BEFORE THE PUBLIC SERVICE COMMISSION
OF THE STATE OF MISSOURI

| 2011 Utility Resource Filing pursuant |) | File No. EO-2011-0271 |

**COMMENTS OF NRDC, SIERRA CLUB, RENEW MISSOURI, MID-MISSOURI
PEACEWORKS, AND GREAT RIVERS ENVIRONMENTAL LAW CENTER**

Figure 5: Ameren Natural Gas Price Projections Versus EIA's

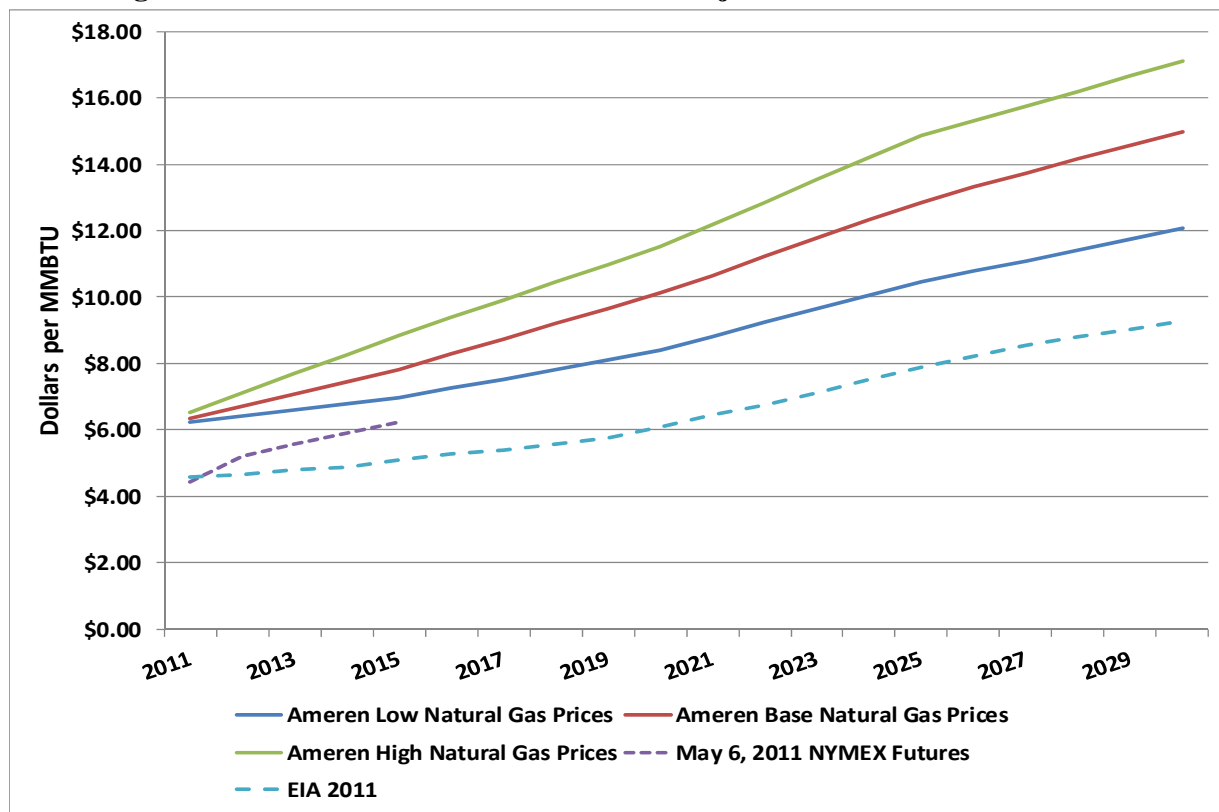
For example, as shown in Figure 5, below, the Base and High Henry Hub natural gas price forecasts that underlie the gas prices used by Ameren in its IRP modeling analyses are significantly higher than current NYMEX futures prices for the years 2011–2015 and the long-term Henry Hub natural gas price forecasts by the US Department of Energy’s Energy Information Administration. Indeed, as this graph shows, Ameren’s 2025 “low” forecast is 30% higher than the EIA’s projection for 2025, and Ameren’s “high” forecast is almost 90% higher than EIA’s projection for 2025. Yet, Ameren assigns its “high” forecast a 50% likelihood in the probability tree, significantly distorting the analysis against plans that include new natural gas capacity, and toward the continued operation of Meramec.

Moreover, as can be seen from Figure 5 above, Ameren's projected Henry Hub prices remain much higher than recent NYMEX prices for the years 2012–2015. This is further evidence that the natural gas prices that Ameren used cannot be relied upon and the conclusion that these prices are far too high cannot be avoided. For this reason, the Commission should not accept Ameren Missouri's conclusion that continued operation of the Meramec coal plant is the preferred option over the unit's early retirement and replacement.

Figure 6: CO₂ Prices - Ameren vs. Synapse 2011

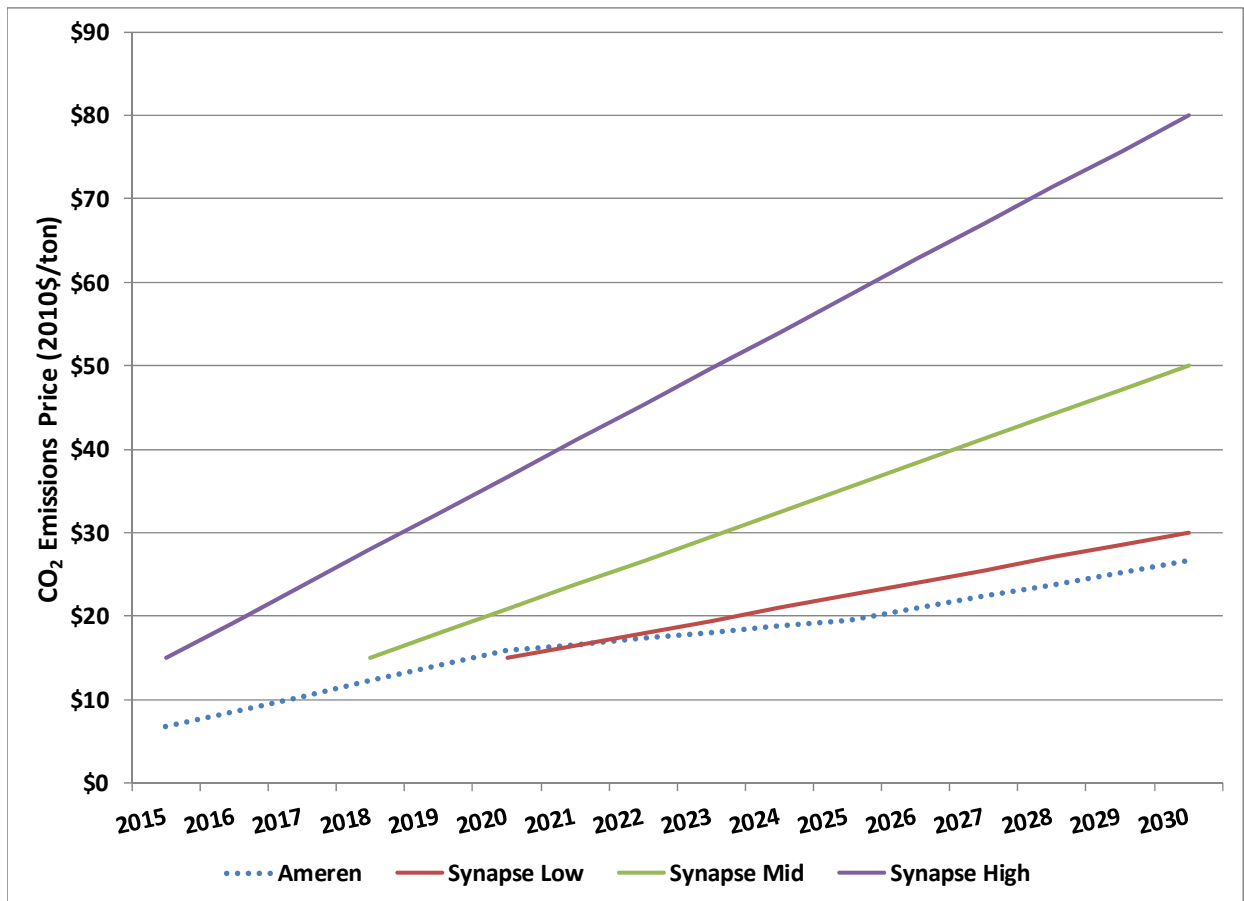
Figure 6 below compares the CO₂ prices used by Ameren in the limited set of scenarios where it does assume there will be regulation of greenhouse gas emissions with the 2011 CO₂ price forecasts from Synapse Energy Economics.

As can be seen from this figure, the single set of CO₂ prices used by Ameren is lower than even the Synapse Low Forecast. See Synapse’s *2011 Carbon Dioxide Price Forecast* for an explanation of how the Synapse Low, Mid and High CO₂ price forecasts were developed.

Remedy: Ameren should revise its planning scenarios and risk analysis to reflect a more realistic range of probabilities for carbon regulation in the 5, 10, 15 and 20 year timeframes, and assume CO₂ costs that are consistent with those ** ** and Synapse.
